1.1 **Minnesota Plumbing Board**

1.2 **Proposed Permanent Rules Adopting the 2018 Uniform Plumbing Code with**
1.3 **Amendments**

TABLE 313.3.1

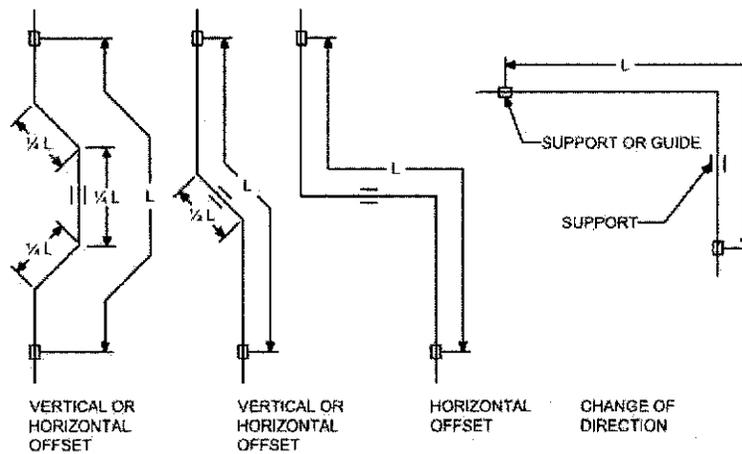
7.9 Subp. 2. **Section 313.** Table 313.3.1 is added to read as follows:

Schedule 40 PVC and ABS DWV and Storm Pipe Expansion Table

8.10 ¹ Multiple offsets shall be allowed to provide expansion for each 30-foot developed length
 8.11 of run.
